FIRE RISK MANAGEMENT, INC

Memo Report

Subject: Code Review and Life Safety Evaluation; ICW Building Located at 106/108 High St., Portland, ME

SKETCH 1 – FRM Code Review & Life Safety Evaluation

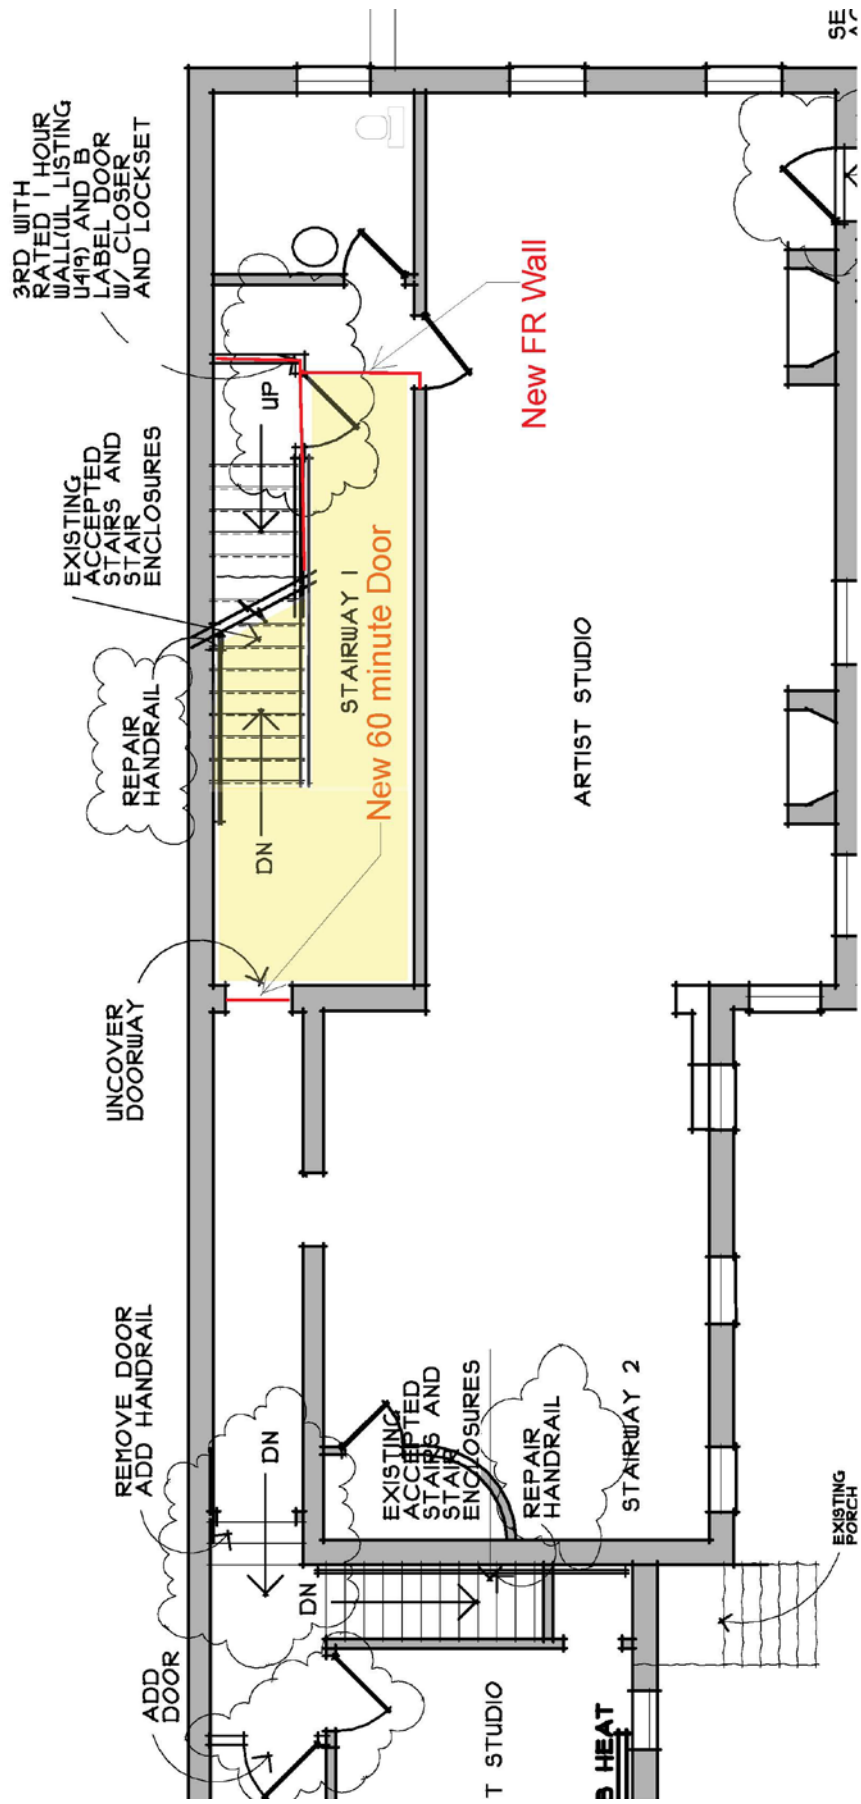
- The corridor adjacent to stairway 1 at the 2nd floor level needs to be isolated from the rest of the building by barriers having a 1-hour fire resistance rating since this corridor is to become part of the new stair enclosure for the 3rd floor occupants. This can be accomplished by the addition of a new fire-rated barrier at that isolates the corridor from the two doors that currently provide access to the business occupancy (artist studio) and bathroom. This space can still be accessed by the doorway from the adjacent corridor. A new fire-rated door is to be installed in the opening that separates stairway 1 from the adjacent corridor to the south that leads to stairway 2. The shaded area shown in the attached sketch (Sketch 1) represents the new “enclosed” area that will be isolated from the rest of the second floor area; thereby providing 3rd floor occupants a means of egress that is completely separated from the rest of the building, from the point that they leave the 3rd floor level to the point they exit the building. The “red” lines shown on this sketch indicate where fire-rated doors and walls must be provided.

Based on the construction of the building, the existing walls should have an inherent fire resistance of at least one hour. However, any penetrations/openings in the existing walls that are to form part of the new stair enclosure must be properly sealed/protected.

- The stair enclosure at the bottom of the stairway from the 3rd floor should consist of barriers, including the doorway, that have at least a 1-hour (60 minute) fire resistance rating. Even though the estimated occupant load for the 3rd floor is less than 50, the door of this enclosure should still be designed to swing in the direction of egress.
